Service Bulletin

Subject: Availability of Insulator Service Part for Prevention of Liftgate Rust/Corrosion at Center Applique

Models: 2010-2015 GMC Terrain

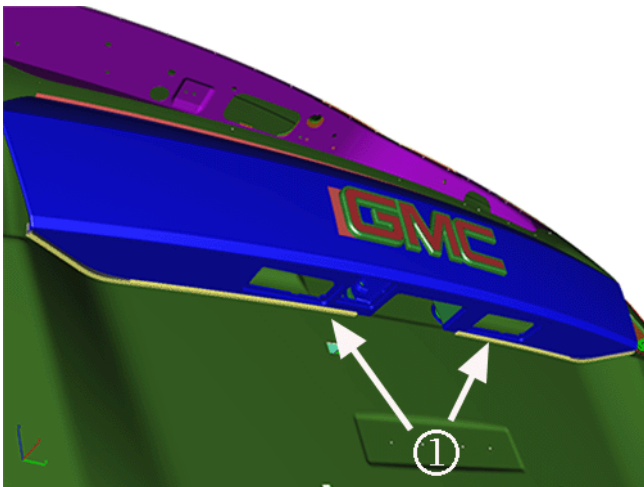
On some vehicles, due to the applique contacting and rubbing on the liftgate painted surface, rust spots (shown circled above) may be evident at the lower corners of the center chrome applique on the rear liftgate.

When repairing this rust spot condition, a new two-piece insulator service part (1) should be installed between the applique and the liftgate.

Prior to installing the insulator, it will be necessary to remove the original applique and repair any rust spot condition following common industry standards. For removal and reinstallation of the applique, refer to Liftgate Applique Replacement (Terrain), in SI.
